**PUR-1270
ADDENDUM NO. 5
INVITATION TO BID**

CONOCOCHEAGUE TREATMENT PLANT ENR UPGRADE

DATE: Thursday, May 26, 2016

4 SECTION
 S-13 SCALE: 1/2"=1'-0"

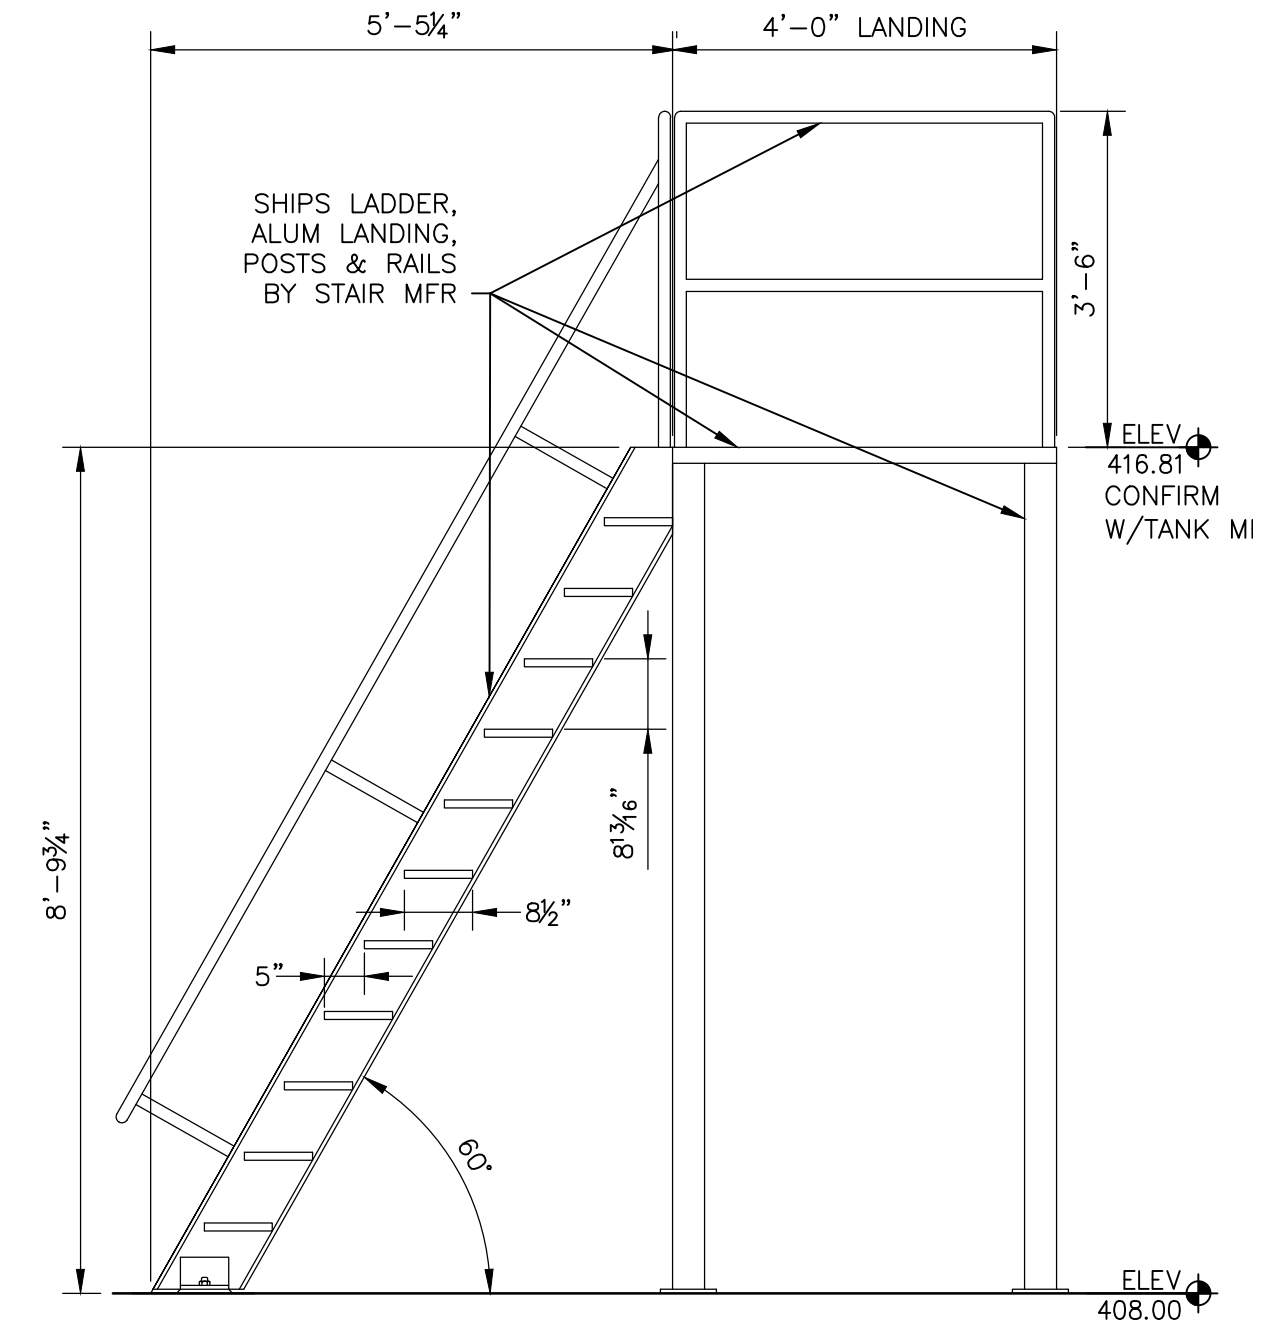
ITEM NO. 5: *Inquiry:* Drawing PM-22 shows a concrete stair outside of the footprint of the Methanol structure with no below grade support. Please provide information for the foundation for this stair.

ITEM NO. 24: *Inquiry:* Drawing S-14 note 3 calls for plastic bird screen mesh on the underside of roof trusses & S-13 shows metal panels only on the structural steel. Detail 3 on A-6 calls for metal soffit on the underside & shows metal panel & plywood on the vertical side of the trusses. What is correct & should the plywood and metal panels be on the vertical as well as across the top of the trusses or only across the structural steel per S-13?

Response: See revised Sheets S-13 and S-14 attached to this Addendum.

Response: The architectural details are correct. See Detail A and E on Sheet A-6.

DRAWING NO.: S-26
 SHEET NO.: 124 OF 327
 SP-15-028

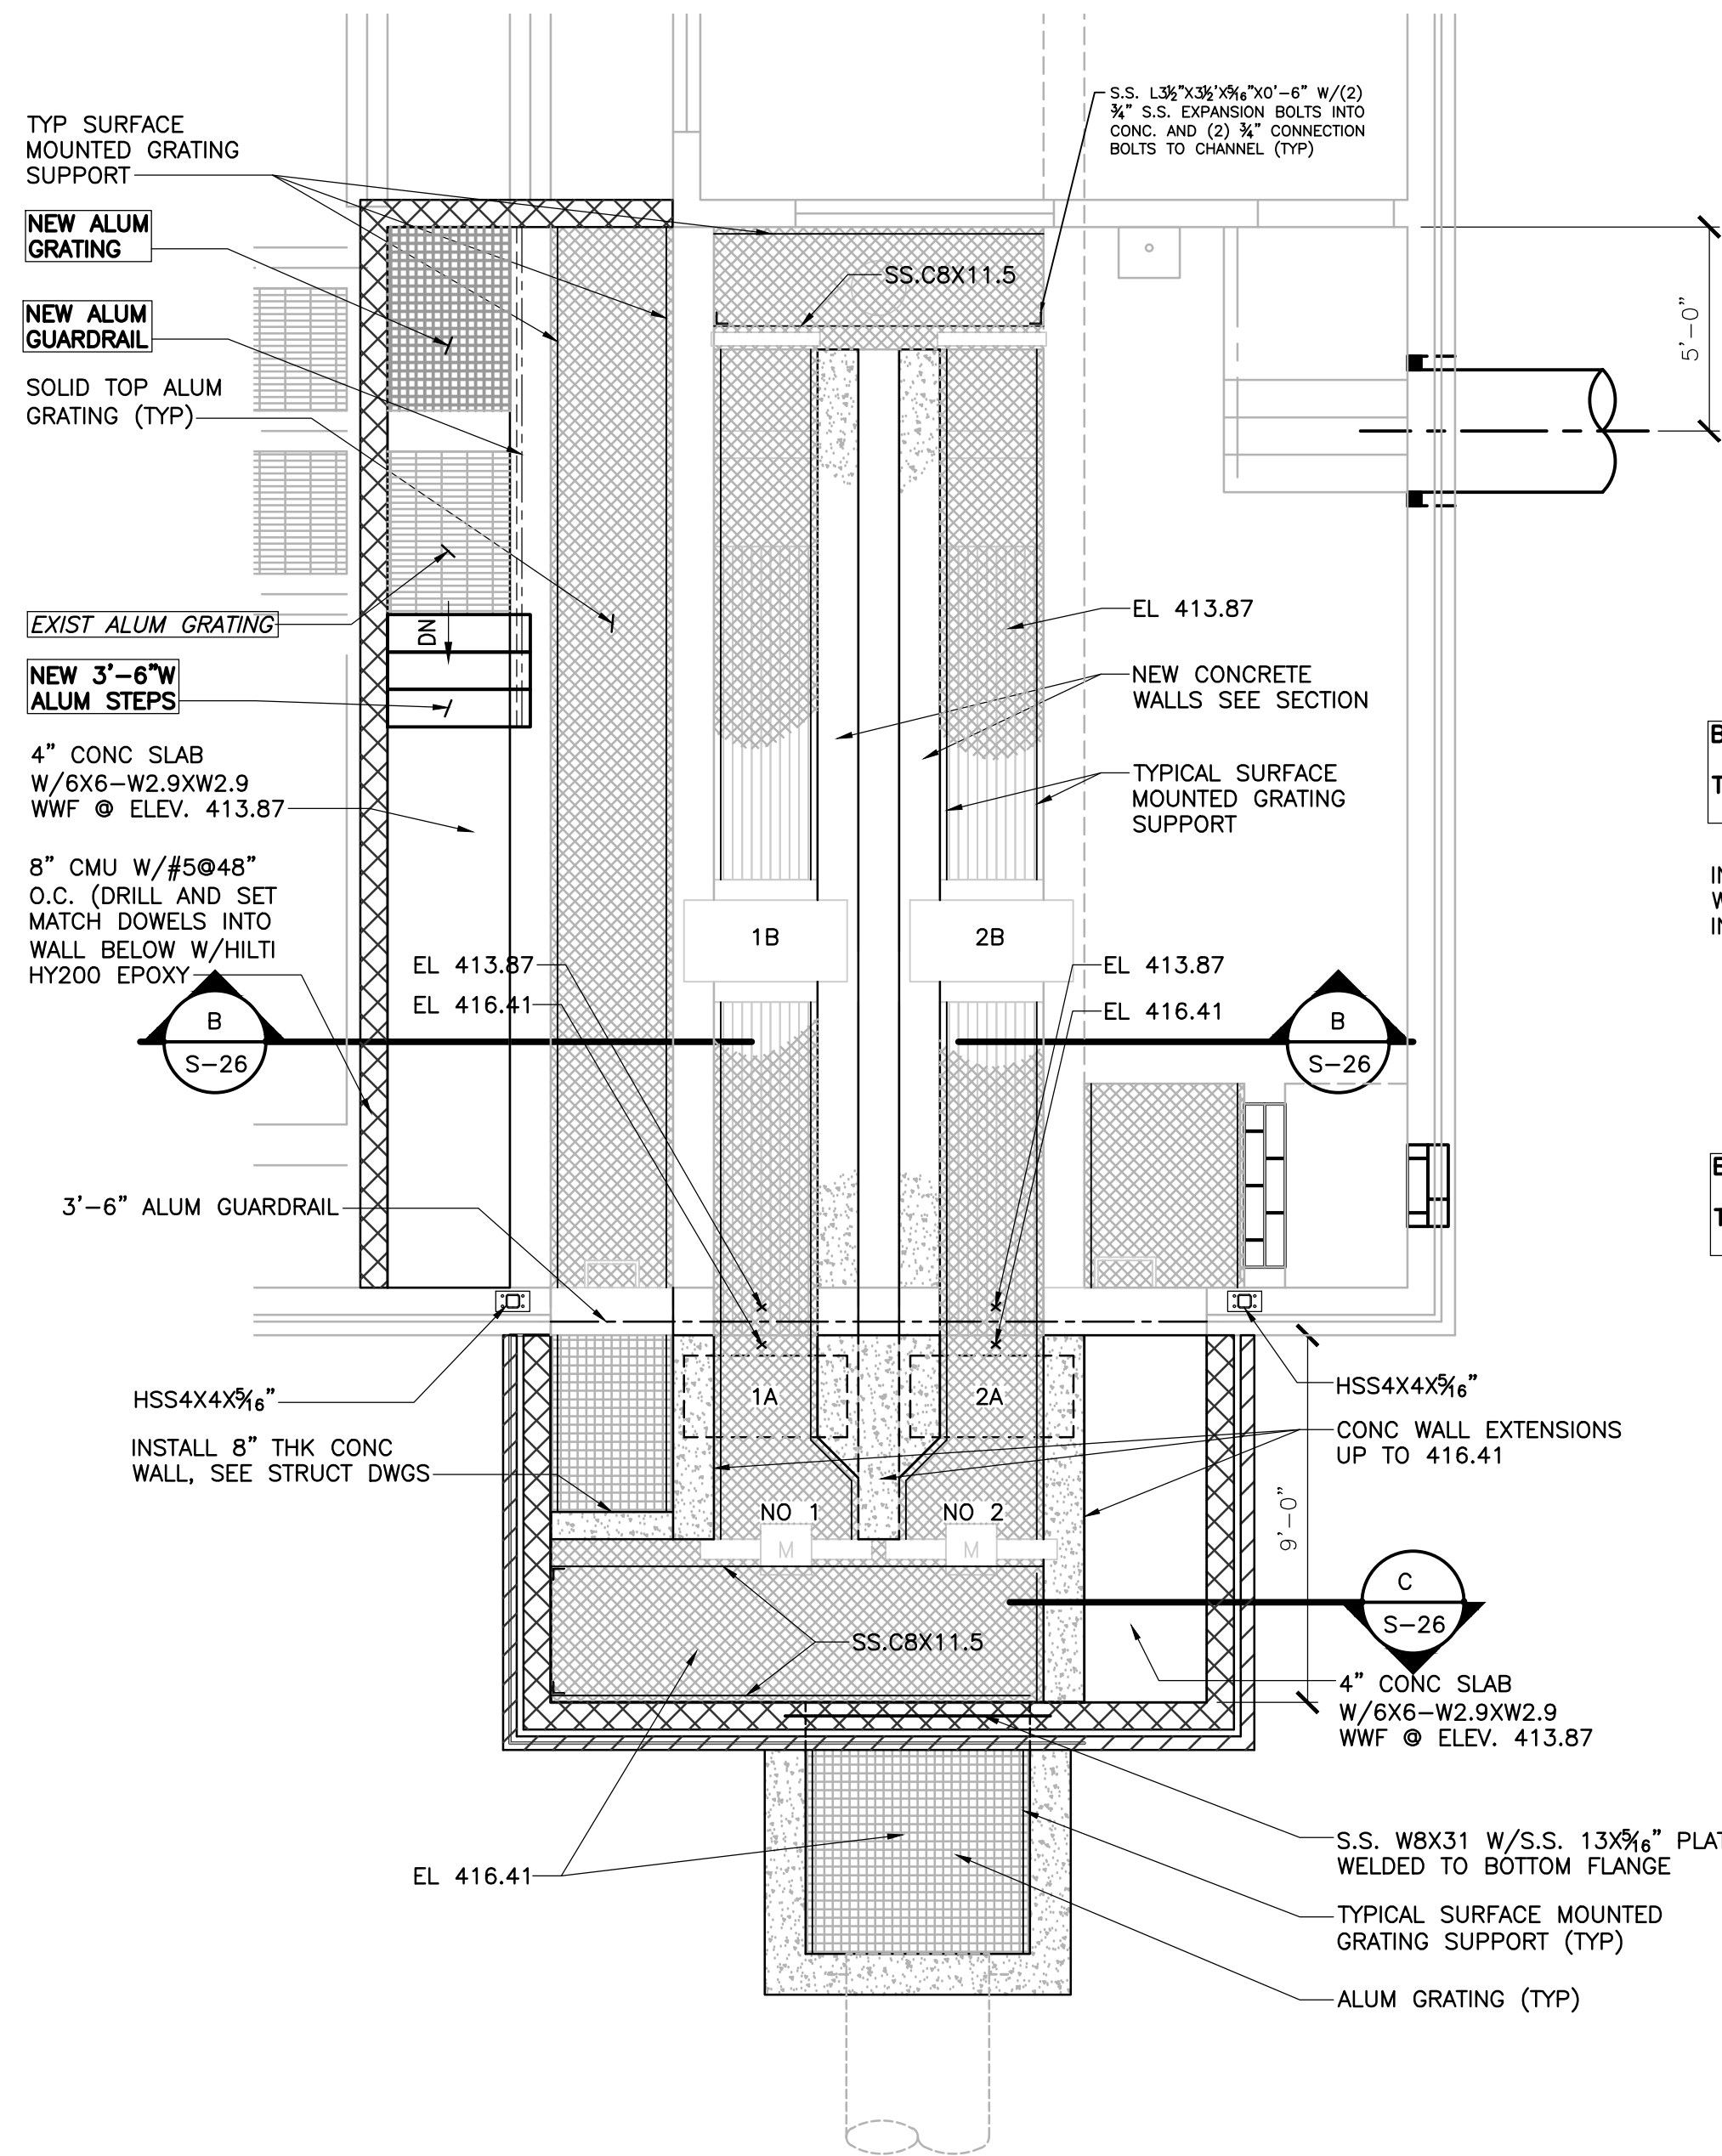
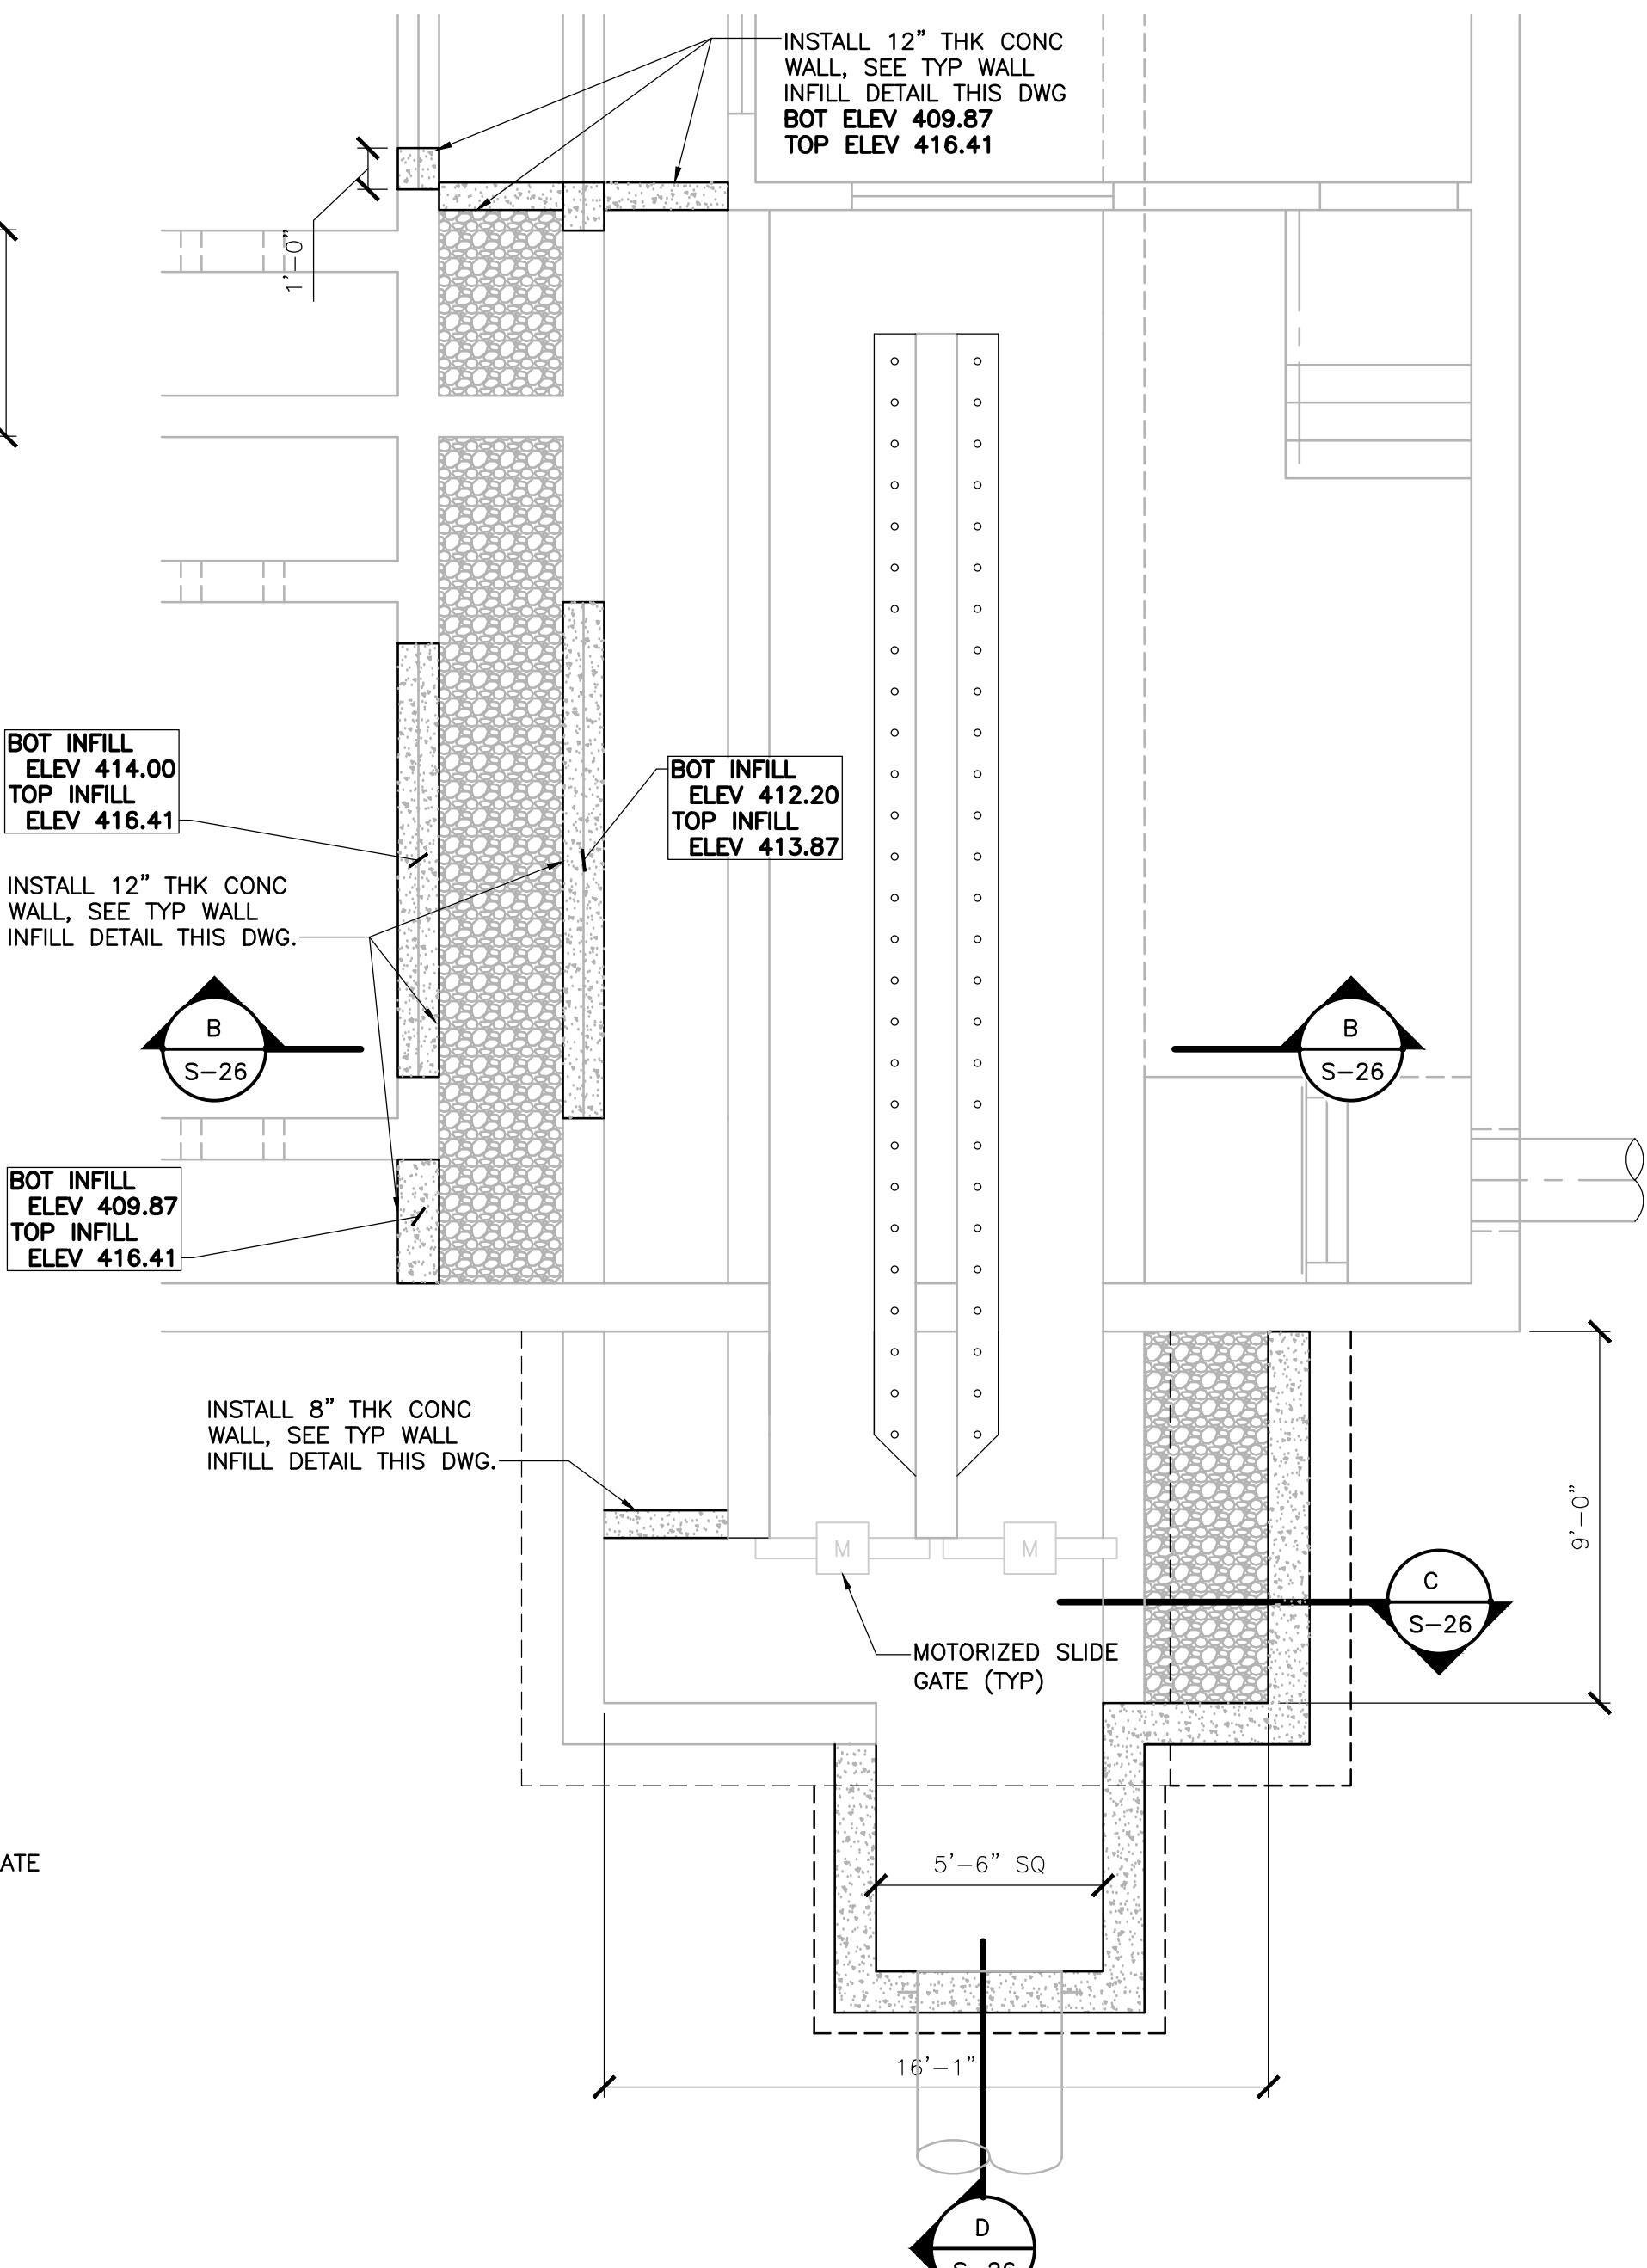
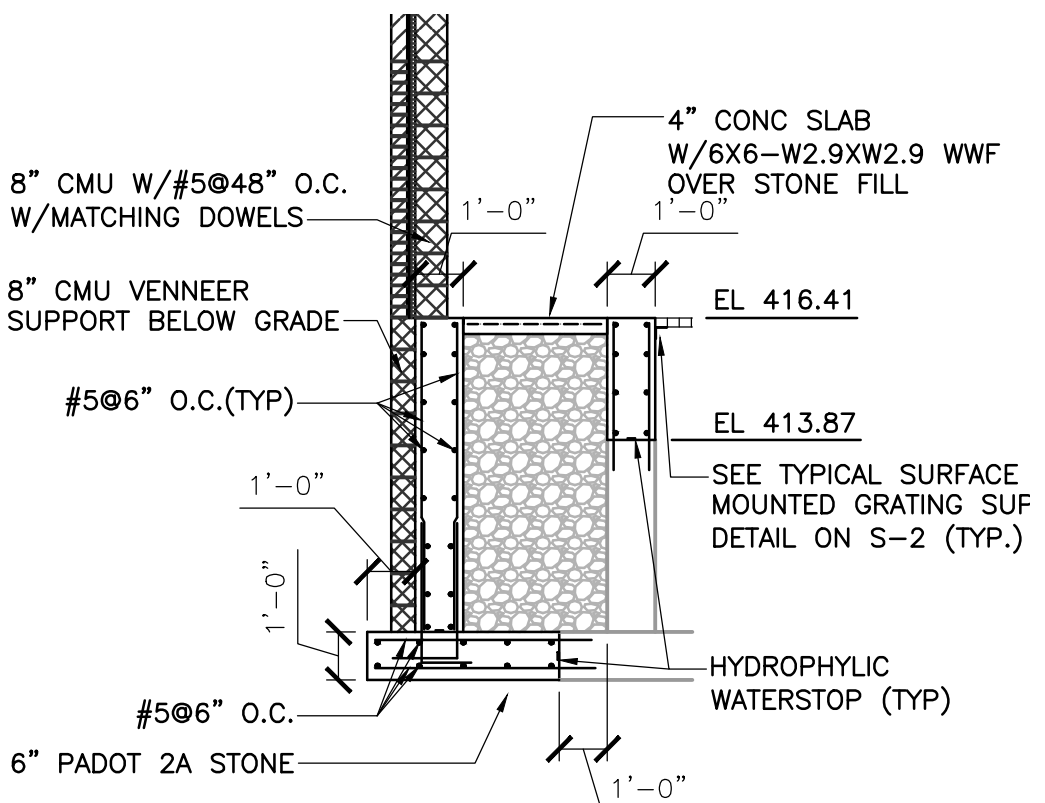
ITEM NO. 29: *Inquiry:* Drawing S-26 Filter/UV Building section 1. Will the exterior walls not shown in detail C/S-26 need to be extended in height the same as the trough walls?

ITEM NO. 43: *Inquiry:* Drawing S-26 has a note near the upper left hand corner of the floor plan (detail 1) that says existing grating & new aluminum steps see ENV drawings. Drawing PM-39 shows 3 steps leading up to something. Is what it leads up to the aluminum grating that is already there? If so, are we to remove that to fill this area with stone as shown on S-26 & then put the grating back or does this get concrete slab poured under the grating as well? PM-35 actually shows some of the grating to be removed that is existing in front of where the new door is going which we would need as part of the “platform”. Please clarify what this area is to look like when the work is done.

Response: Yes.

Response: See revised copy of Drawing No. S-26 attached to this Addendum which should better clarify the work required.
